Subject: Tucson Medical Center Architectural Design Guidelines – Tucson Medical Center Planned Area Development (PAD-16)

SUBJECT: Clarification of TMC Strategic Capitol Plan Improvements as Related to the Tucson Medical Center Planned Area Development

SUBJECT: Clarifications Regarding TMC Development Plan as Related to the Tucson Medical Center Planned Area Development

Subject: Minor Amendment for Tucson Medical Center (TMC) Planned Area Development – Above Ground Fuel Storage Modification

TMC DEVELOPMENT PLAN
EXHIBIT 'D'
NORTH

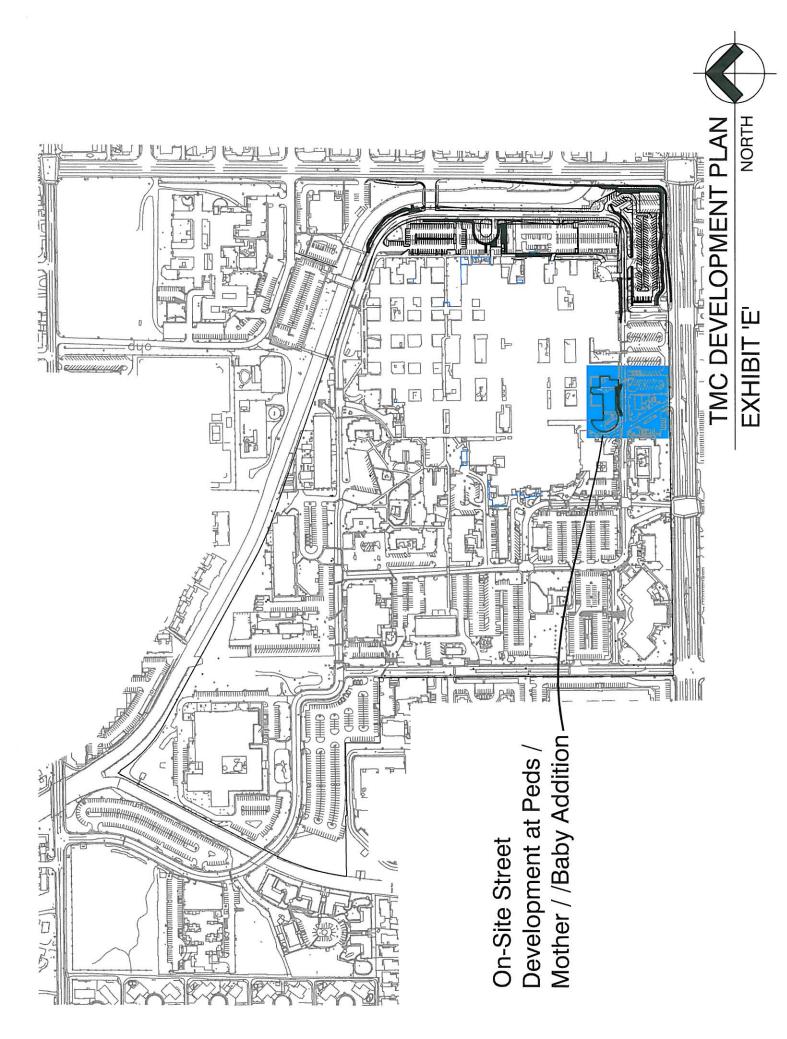
Issue 4, Pedestrian Sidewalks within the PAD District, specifically at the proposed MOB

The main entrance to the MOB is intended to be at the Southwest corner, adjacent to the existing Women's Center entrance. Additional entries will be provided at each level of the parking structure on the Northwest corner. With these entries, it is anticipated that there will be minimal if no pedestrian traffic on the East and South sides of the MOB, thus the need for a pedestrian sidewalk does not exist. Pedestrian access will be available to travel North and South between the existing structure and the MOB/parking structure. A pedestrian crosswalk will also be provided at the Southwest corner of the MOB to provide access from the new parking lot to the South. The PAD District suggests that sidewalks or pedestrian paths be provided on both sides of a street or roadway except if development is only on one side of the street or roadway, the sidewalk or pedestrian path may be provided only on the side of the development. COT staff has also indicated that the Development Standards require sidewalks adjacent to a building, but that the presented concept may warrant an exception.

Please refer to the attached exhibit 'D' for a site plan that identifies the Pedestrian Sidewalks within the PAD District, specifically at the proposed MOB.

TMC and the design team would like clarification that this interpretation of the PAD District requirements and the Development Standards is an approved option for Pedestrian Sidewalks within the PAD District, specifically at the proposed MOB.

- Pedestrian Sidewalks within the PAD District, specifically at the proposed Medical Office Building – the request to eliminate pedestrian sidewalks along the eastern and southern edges of the MOB can be supported (but a DSMR would be needed) as the main entrance to the MOB is intended to be at the southwest corner, and an additional entry at the northwest corner of the building, with no anticipated pedestrian traffic on the east and south sides of the MOB. There are to be no access points along the east and west sides of the MOB. Pedestrian access to travel north/south between the existing structure and the MOB/parking structure should be clear and easily available.

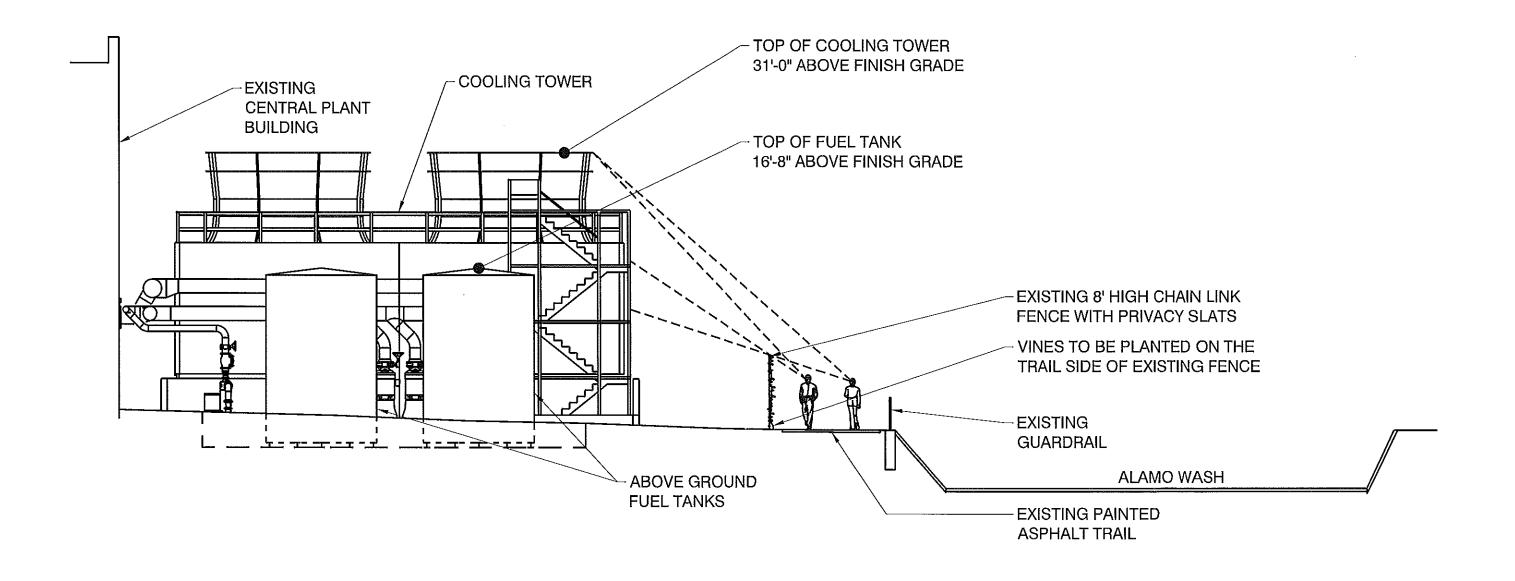
The PAD also specifically references in its section 3.3.6 Landscape, Screening and Buffering, 3.3.6.A.4, that 'Trail screening adjacent to the power plant, storage areas, vehicular parking areas and streets or roadways may include vegetation, masonry walls, wrought-iron fencing, or a combination thereof.' TMC is proposing that the existing chain link fence be kept in place and landscape vines be planted and irrigated on the north side adjacent to the trail in an effort to meet the screening requirements. The attached partial site plan and section through the equipment yard, trail and Alamo Wash illustrate the existing heights and sight lines.

- 3. The proposed location of above ground fuel storage tanks up to 25,000 gallons in size in the central plant and equipment yard area is consistent with existing Campus infrastructure locations and the proposed storage tank height of 17 feet falls well below the allowed structure height of 40 feet shown on Figure 20 -Building Height Zones of the Plan;

- 5. Retaining the existing chain link fence with a vine hedge planting meets the spirit of landscaping and screening requirements, subject to Architectural Review Board approval.
